GOVERNMENT OF THE DISTRICT OF COLUMBIA
DEPARTMENT OF TRANSPORTATION

MEMORANDUM

SUBJECT: Zoning Commission Case No. 14-19 – 300 M Street NE

Figure 1 Site Design and Access (Source: Gorove/Slade)

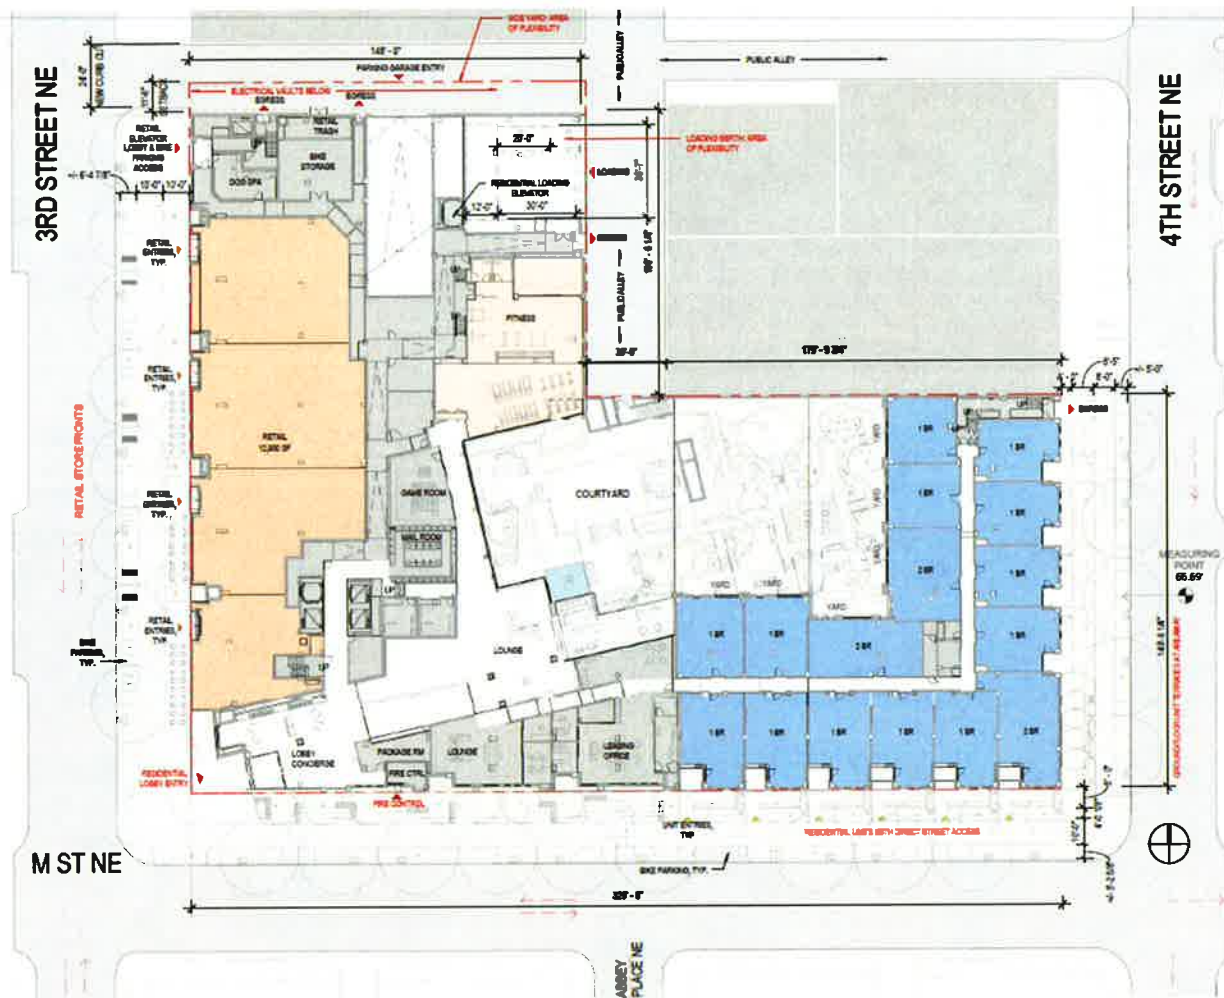
The Applicant proposes widening a portion of an existing 14.75' public alley to 24'. The proposed widened alley runs east-west between 3rd and 4th Streets and connects to an existing north-south public alley that is adjacent to the site. The widened alley would extend onto the Applicant's private space through an easement beginning at its intersection with 3rd Street. Widening the alley will enable vehicular, loading, and trash access as trucks can perform turning maneuvers. The proposed site access location and size complies with DDOT's approach to site access.

The Applicant proposes to provide two 30-foot deep loading berths, rather than the required single 55-foot deep loading berth. The loading berths are accessed from the 3rd Street widened alley. The Applicant's proposed loading locations comply with DDOT's loading requirements. The Applicant's analysis includes AutoTurn diagrams showing that truck maneuvers can be accommodated in the alley,

in keeping with DDOT standards. The design of the loading facilities would enable simultaneous loading for both residential and retail uses, for which loading is not required. Given the proposed land uses, this relief is appropriate and unlikely to negatively impact the District's transportation network. Trucks that are too large to utilize the on-site loading facility may occasionally need to serve the project and can apply for Emergency No Parking signs for curbside access on 3rd Street.
